Oregon Water Resources Department
 725 Summer Street NE, Suite A
 Salem, Oregon 97301-1271
 (503) 986-0900
 www.wrd.state.or.us

Ground Water Review Form:

Application: T-12944

Applicant Name: Margaret & Thomas Barnett

This Time-Drawdown Worksheet v.3.00

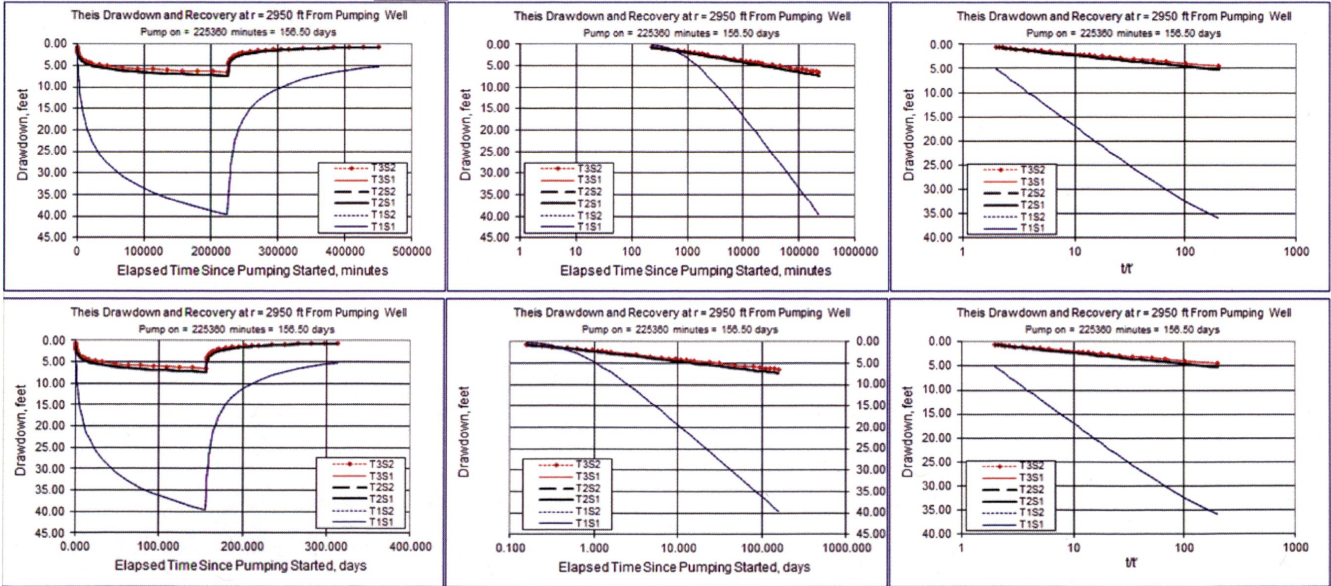
Under the most conservative parameters (transmissivity of 500 ft²/day, storativity of 0.0001, pumping regime as described above), use of the APOA (Well 2/MARI 62290) is projected to result in less than 1 foot of additional drawdown at the nearest other groundwater use, MARI 54092. The maximum cumulative

interference at MARI 54092 due to pumping of both the POA (Well 1/MARI 286) and APOA (Well 2/MARI 62290) is projected to be less than 41 ft. MARI 54092 is reportedly 156 ft deep with a static water level of 59 ft bls and yield of approximately 25 gpm. As such, there is presumably sufficient available drawdown in MARI 54092, that an additional 1 ft from the proposed transfer (likely a conservatively-high estimate) should not be problematic. Other nearby groundwater right POAs (G-13102 and G-15740/MARI 18911), which are at greater distance from the proposed APOA, would be presumed to experience similarly minimal impacts.
